Location of Construction: <b>73 Shepherd Ln (lot #24)</b>		Owner: <b>Coleman Construction</b>		Phone:	Permit No: <b>941252</b>
Owner Address:		Leasee/Buyer's Name:		Phone:	Business Name:
Contractor Name: <b>Coleman Construction</b>		Address: <b>31 Wendell St Portland, ME 04103</b>		Phone: <b>758-8440</b> <b>797-0034</b>	Permit Issued:
Past Use: <b>Vacant Space</b>		Proposed Use: <b>1-fam</b>		COST OF WORK: <b>\$ 75,000.</b>	PERMIT FEE: <b>\$ 393 + 50.</b>
Proposed Project Description: <b>Construct 1-fam as per plans</b>		FIRE DEPT. <input type="checkbox"/> Approved <input type="checkbox"/> Denied		INSPECTION: Use Group: <b>A2</b> Type: <b>5P</b> <b>BOCA 93</b>	
Signature:		Signature:		Signature:	
PEDESTRIAN ACTIVITIES DISTRICT (P.A.D.)		Action: <input type="checkbox"/> Approved <input type="checkbox"/> Approved with Conditions <input type="checkbox"/> Denied		Date:	
Permit Taken By: <b>Mary Gresik</b>		Date Applied For: <b>8 Nov 94</b>

SUBJECT: Temporary Certificate of Occupancy for 73 Shepherd Lane

**SUBJECT:** Refusal of Temporary Certificate of Occupancy for 73 Shepherd Lane

RE: 73 Shepherd Lane  
Lot 24

43 Sheppard Lane

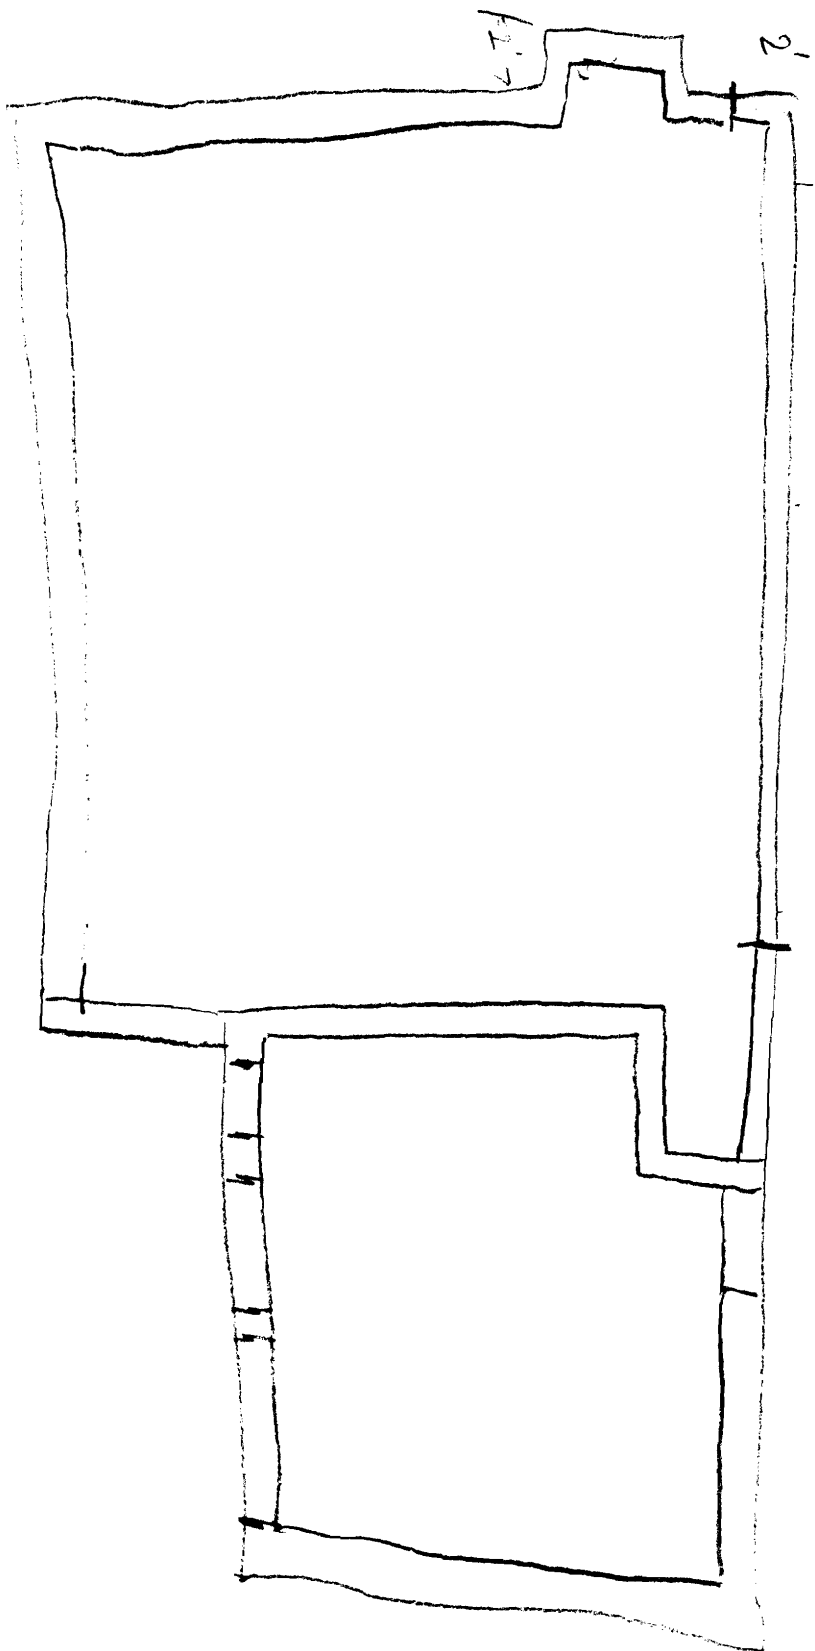
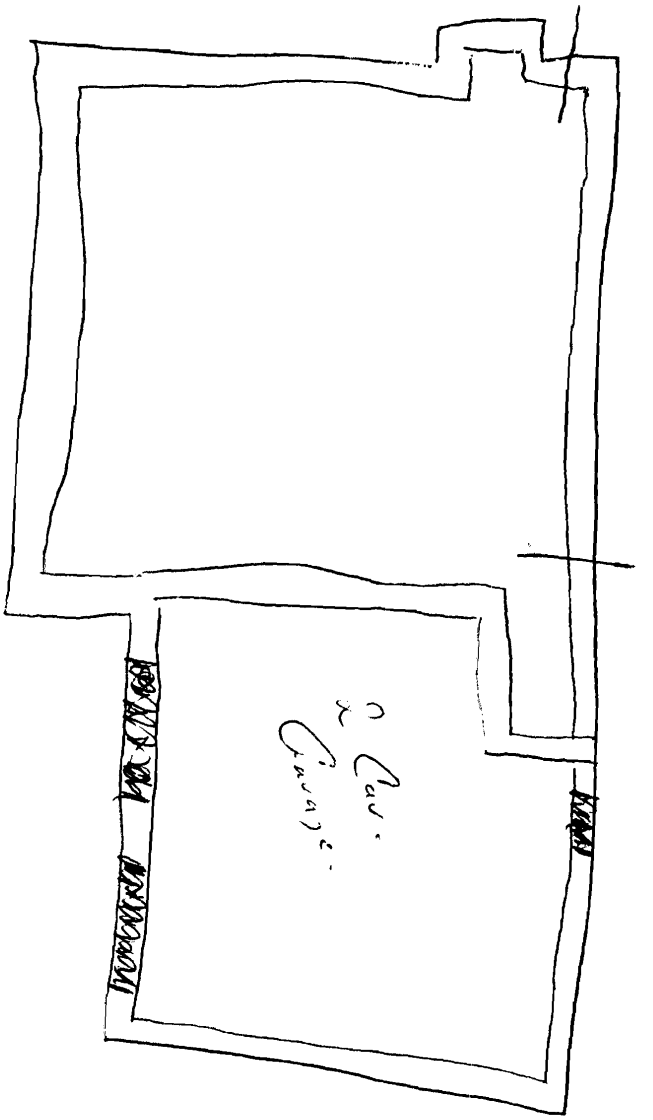
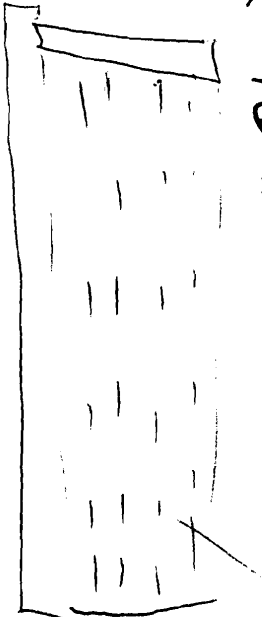
Total of 32' wrapped

Footings not touched

1/2" rebar drilled out & pinned then repaired  
 with 9 rows of rebar. APPROX TO hold rods -
